Co3197 – Colchester HES NH 5600(14) C/2 Re-Ad

ADDENDUM #3

Changes have been made to the documents located on the Bid Opportunity website as noted below:

FILE NAME: t12d046sigl.dgn
PROJECT LEADER: M. LACROIX
DESIGNED BY: B. TIETZE
TRAFFIC SIGNAL PLAN 4A - I-89 NB RAMPS

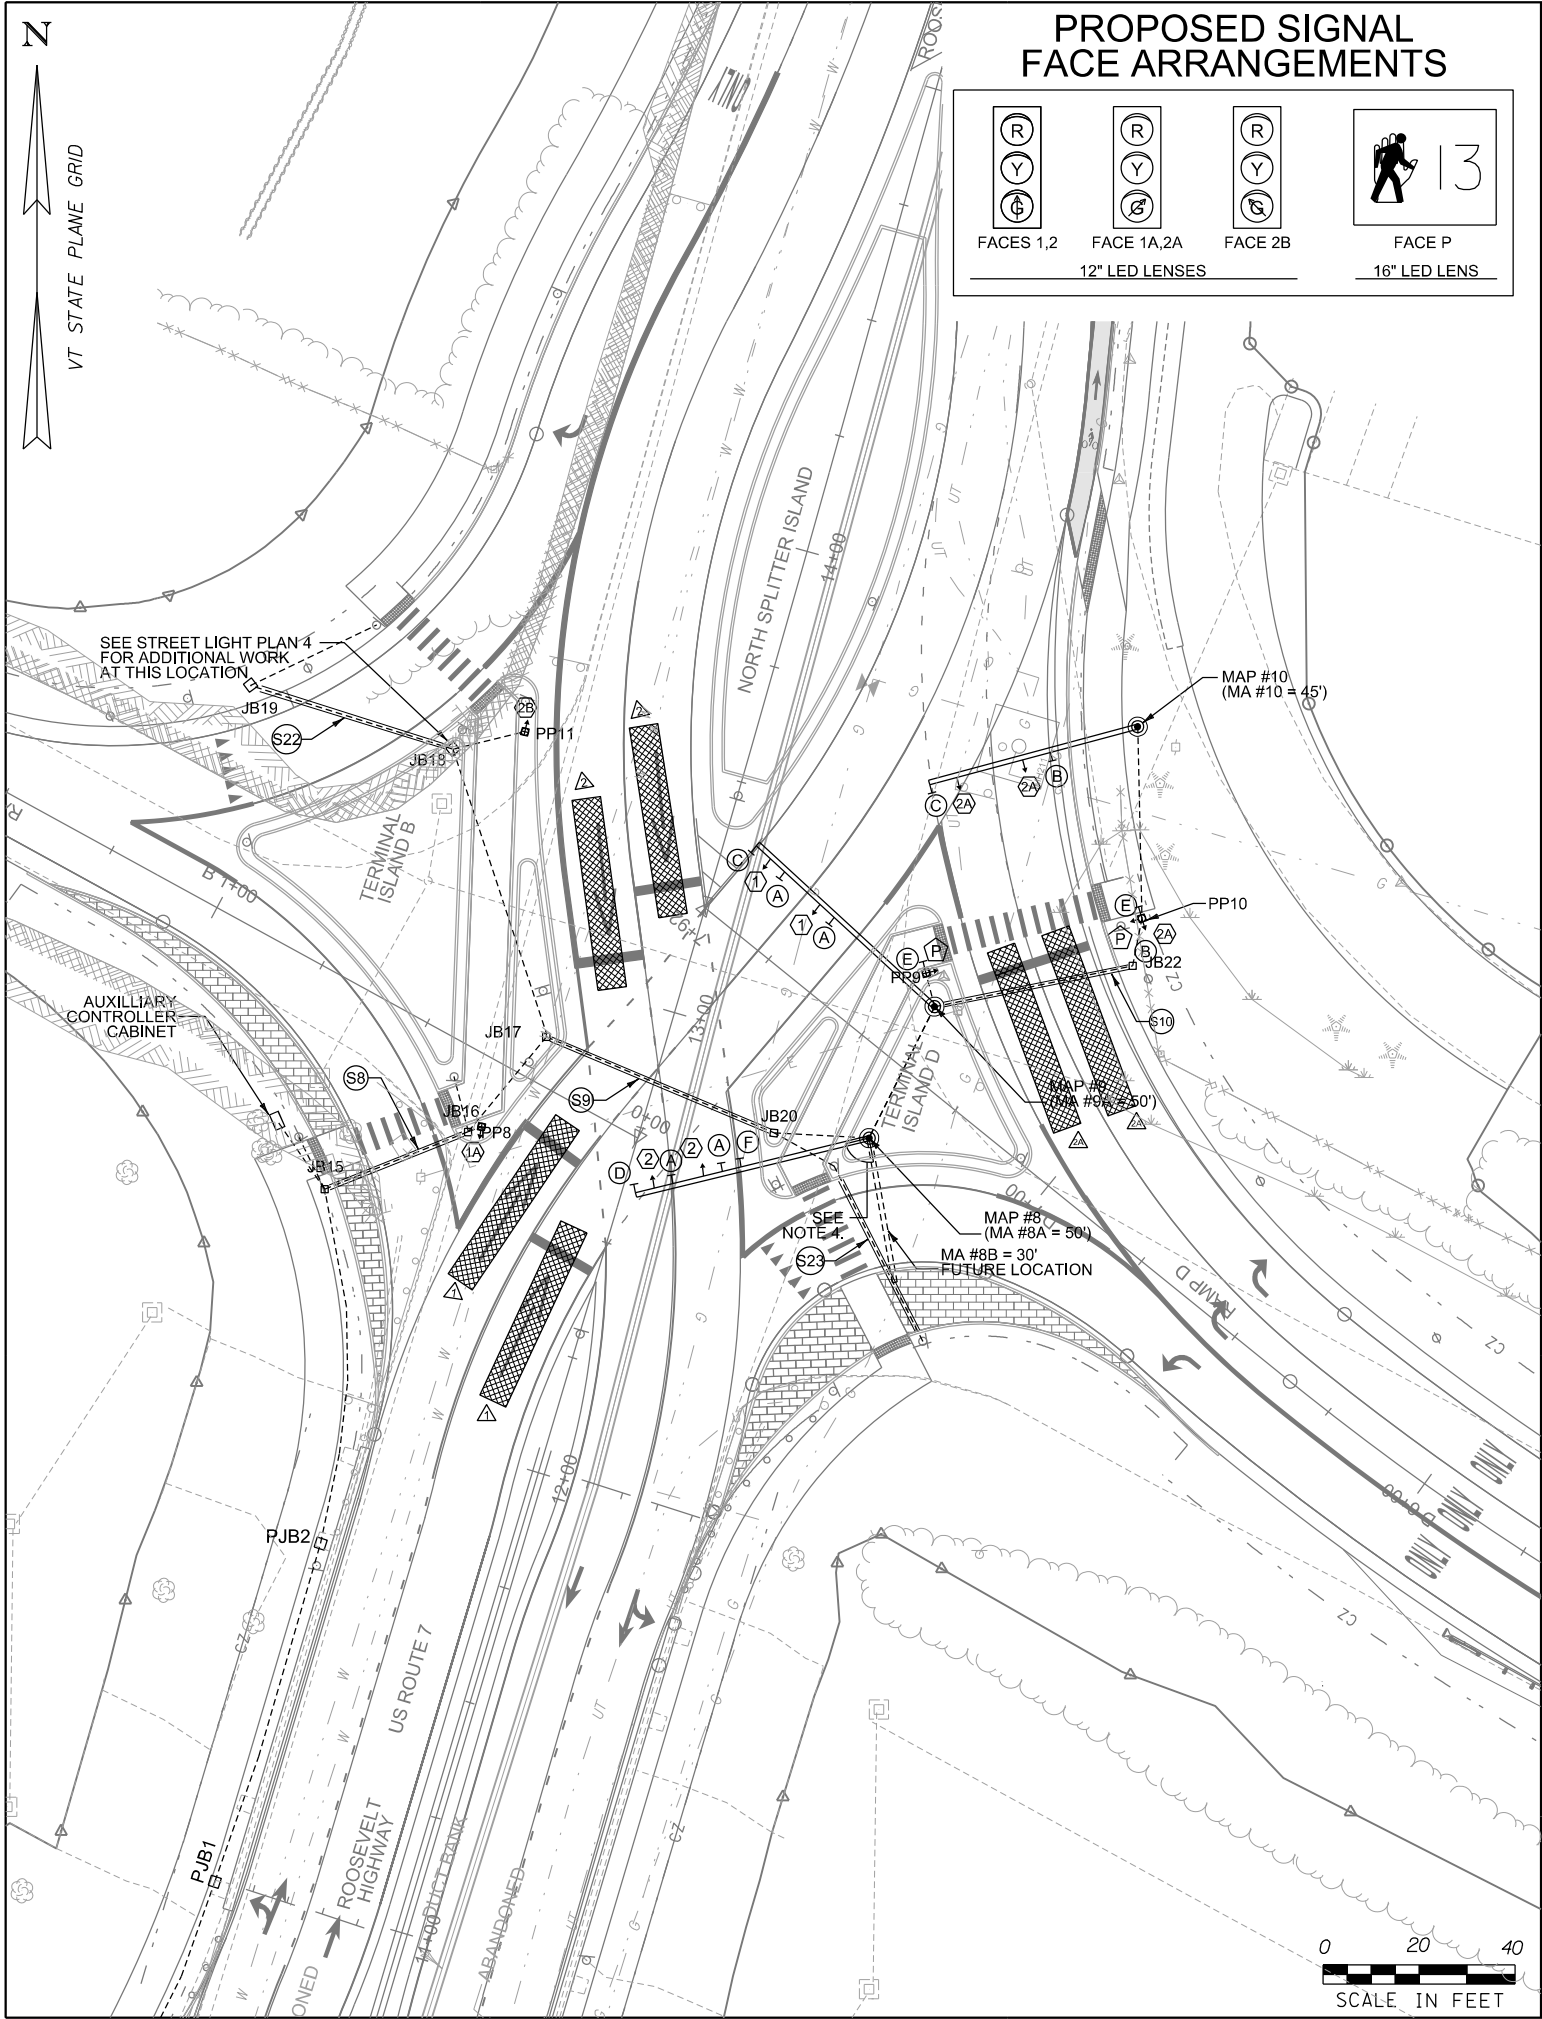
ADDENDUM	REVISION	PLOT DATE	DESCRIPTION	BY
	1	31 MARCH 2025	CHANGES TO CONDUIT SCHEDULE	BJT
	1	31 MARCH 2025	ADDED AXILIARY CABINET	BJT

PROJECT NAME: COLCHESTER	
PROJECT NUMBER: HES NH 5600(I4) C/2 (Re-Ad)	
FILE NAME: fibl.dgn	PLOT DATE: 4/2/2025
PROJECT LEADER: M. LACROIX	DRAWN BY: M. KEMERER
DESIGNED BY: B. TIETZE	CHECKED BY: HSD
SIGNAL INTERCONNECT PLAN SHEET 1	SHEET 319 OF 405

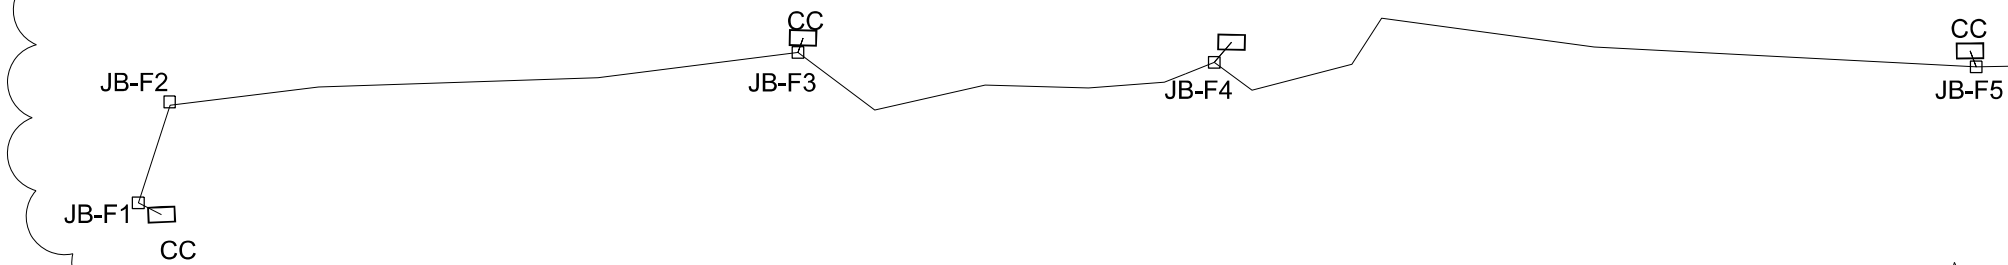
ADDENDUM	REVISION	PLOT DATE	DESCRIPTION	BY
3	1	31 MARCH 2025	NEW NOTES AND LAYOUT	BJT

PROJECT NAME: COLCHESTER	
PROJECT NUMBER: HES NH 5600(I4) C/2 (Re-Ad)	
FILE NAME: fib2.dgn	PLOT DATE: 4/2/2025
PROJECT LEADER: M. LACROIX	DRAWN BY: M. KEMERER
DESIGNED BY: B. TIETZE	CHECKED BY: HSD
SIGNAL INTERCONNECT PLAN SHEET 2	SHEET 320 OF 405

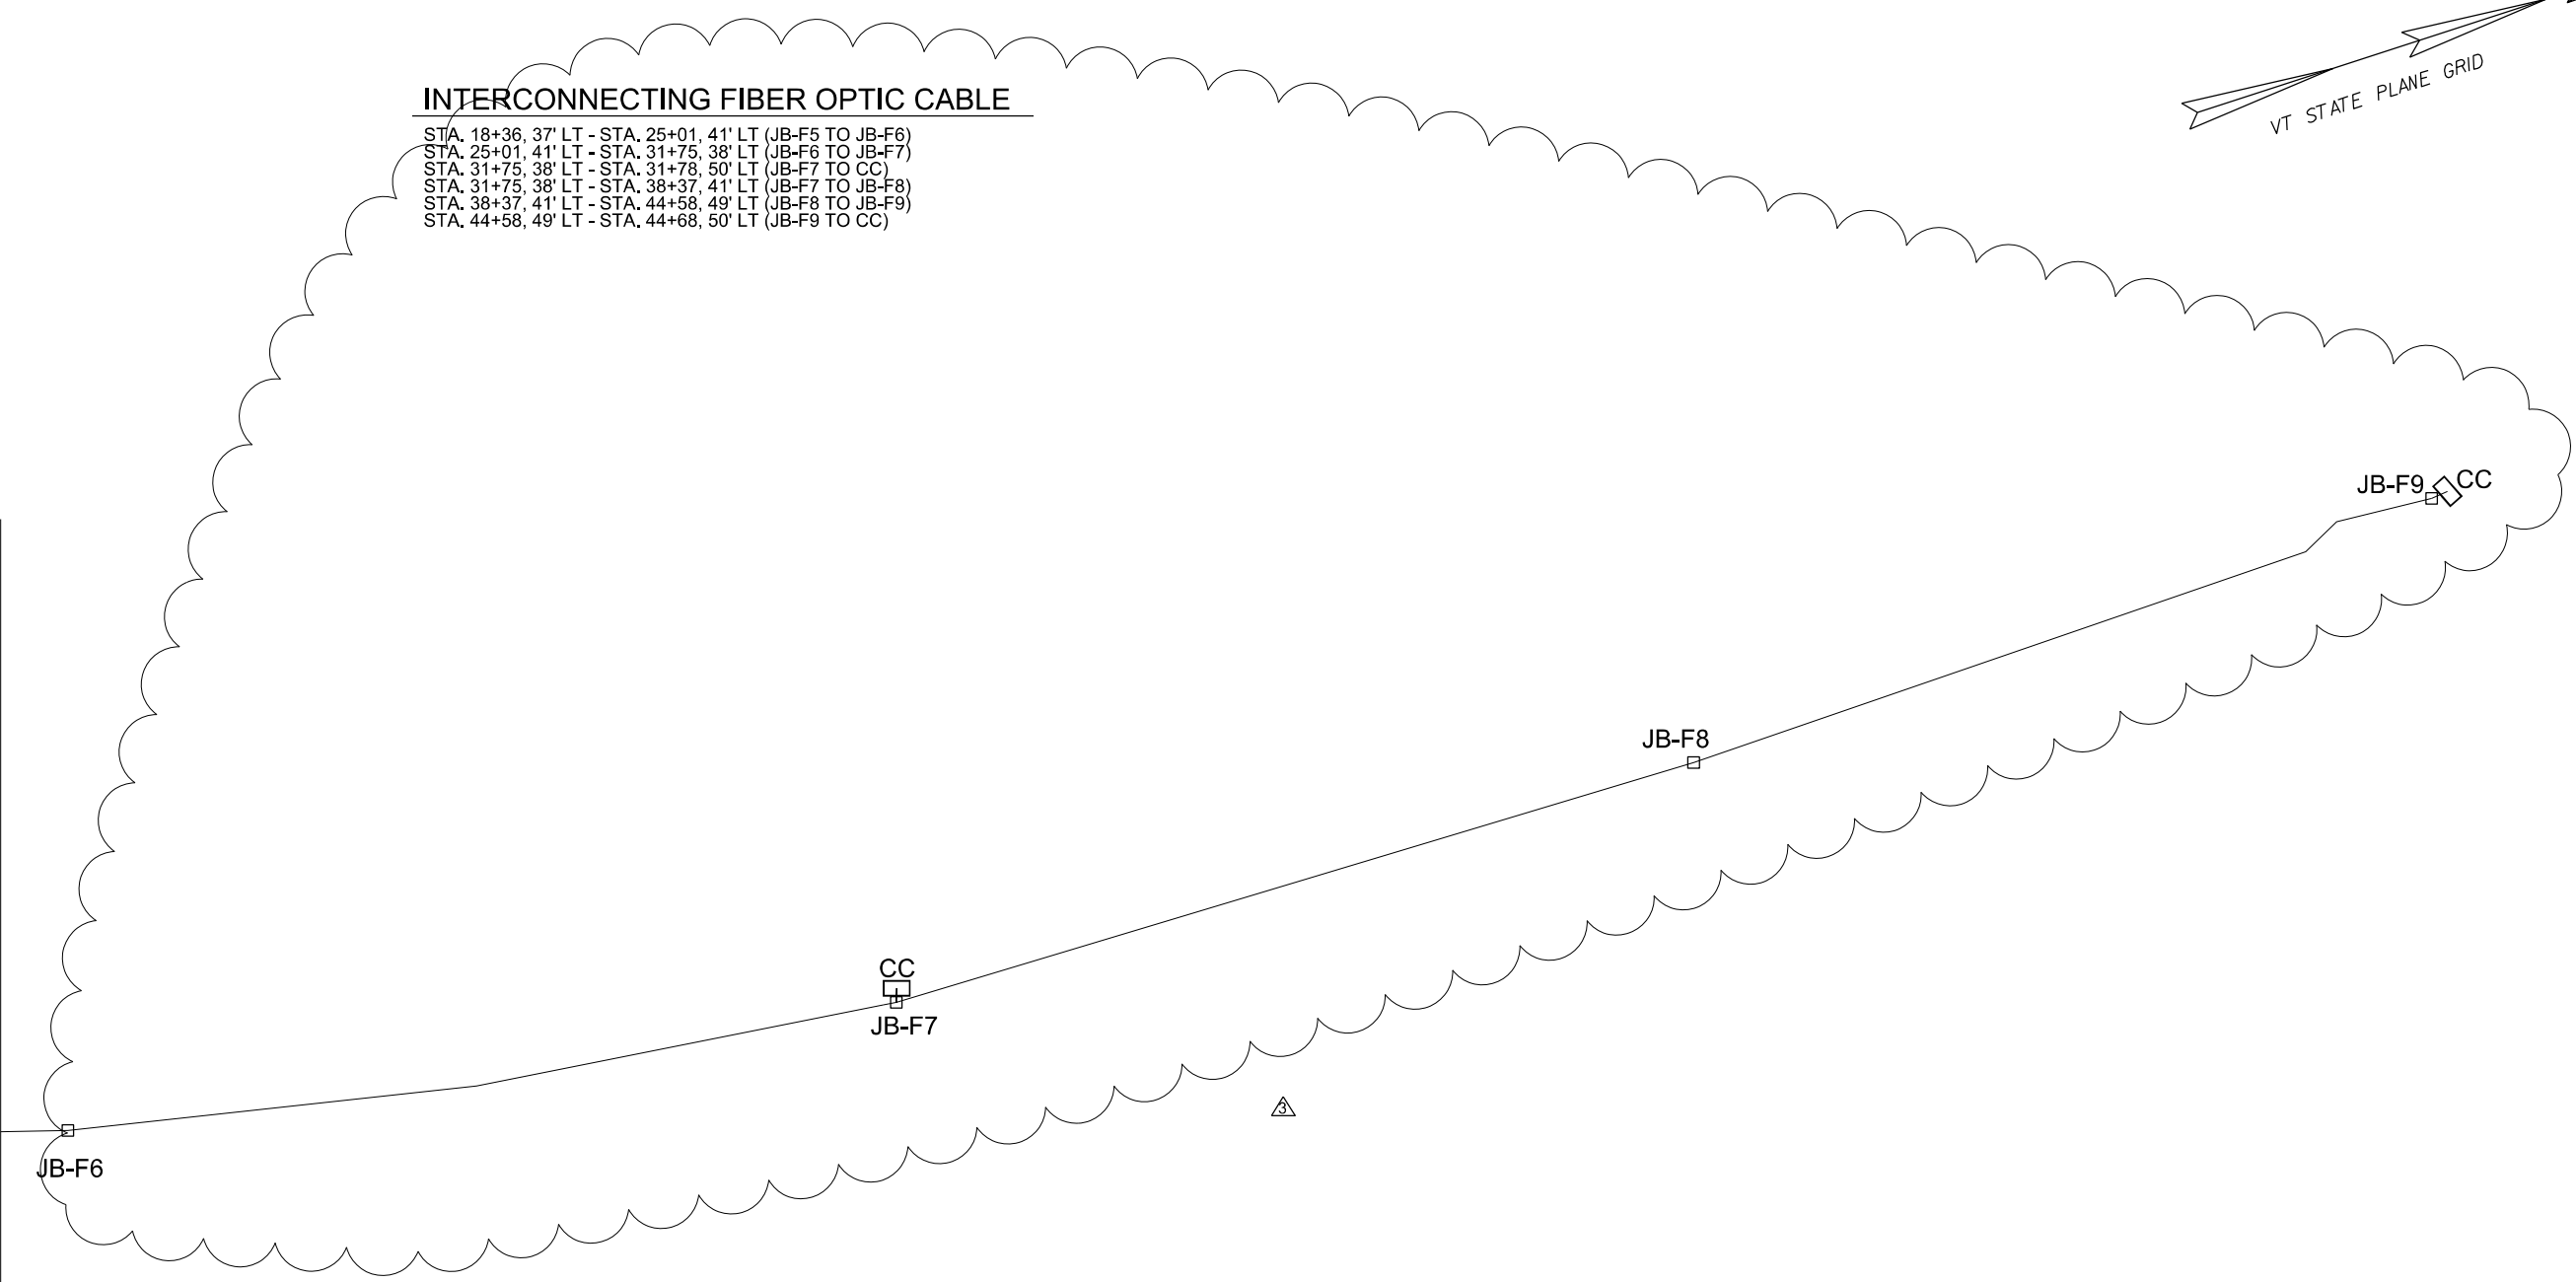
ADDENDUM	REVISION	PLOT DATE	DESCRIPTION	BY
△	1	31 MARCH 2025	NEW NOTES AND LAYOUT	BJT
